14 May 2019 610.17533-L01-v1.2.docx

Concrete Batch Plant NIA, Glebe Island Noise Impact Assessment (SSD 8544) Response to DP&E Request for Additional Information

SCHEDULE 1 - KEY ISSUES

Predicted Daytime, Evening and Night-time Facility Operating Intrusive LAeq(15minute) Noise Contours

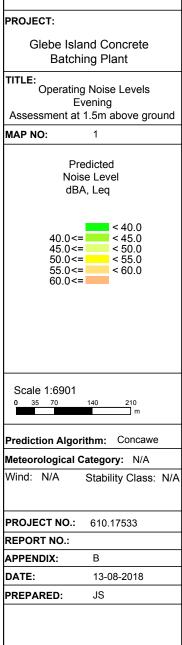
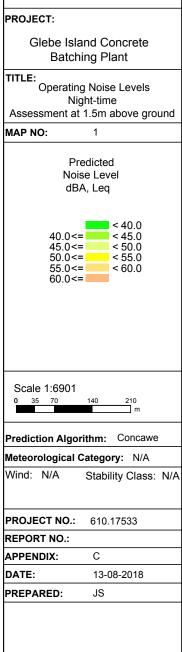
13. Clarify the modelled scenarios by providing noise contour maps of all scenarios in the NIA.

NIA Figure 3 presents proposed Facility layout, NIA Table 13 lists the major items of stationary plant (and mobile equipment) and the associated SWLs for the Facility, and NIA Table 12 describes the Facility (daytime, evening and night-time) noise modelling scenarios. The predicted operating intrusive LAeq(15minute) noise levels from the Facility's three operating scenarios are present in NIA Table 18, the associated noise contours for daytime, evening and night-time are shown in Attachment C.
